WATER QUALITY MEMORANDUM

Utah Coal Regulatory Program

RE: 2007 Second Quarter Water Monitoring, PacifiCorp, Trail Mountain Mine, C/015/0009, Recurring Task # 2713

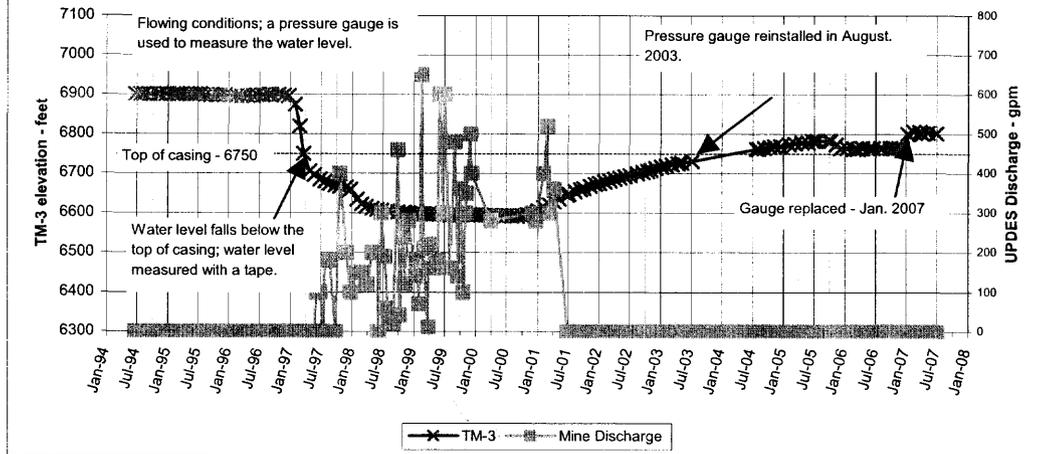
SW-1 June: water temperature, field electric conductivity, Ca, Mg, Na, total alkalinity*, lab electric conductivity*, TDS, total cations*, total anions*;

SW-2 June: water temperature;

SW-3 June: water temperature, field electric conductivity, Cl, SO4, lab electric conductivity*, TDS, total cations*, total anions*;

TM - 3 Water Level - Depth

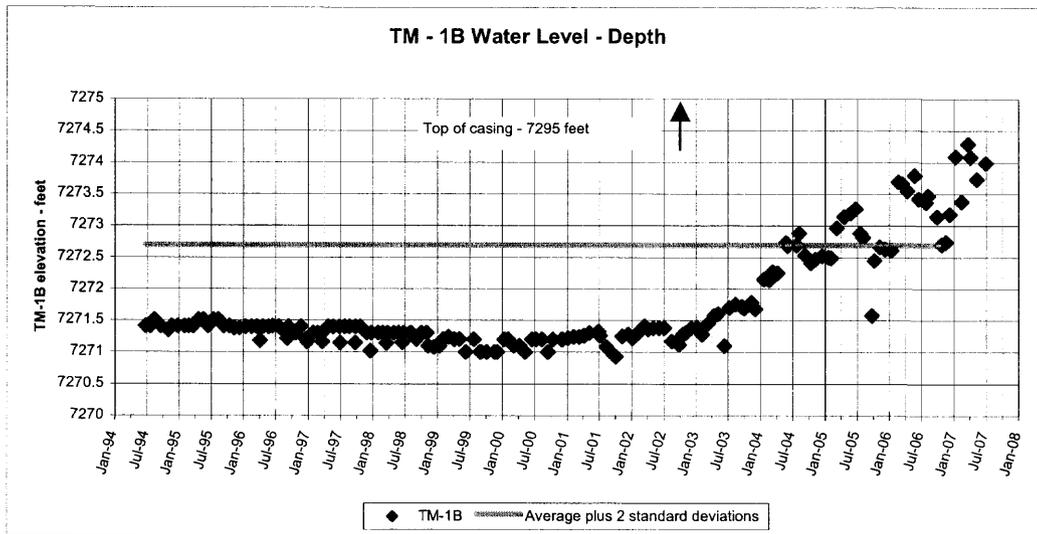
TM-3: water elevation peaked in June 2005, remained steady through October, dropped 18.5 ft in November and December 2005 and remained virtually unchanged during 2006. The pressure gauge was replaced in January 2007 and values jumped to approximately match the pre-2006 curve. During the first half of 2007, the curve has again been relatively flat. See the chart below.

TM-1B: water level has been slowly rising since 2003. See the chart below;
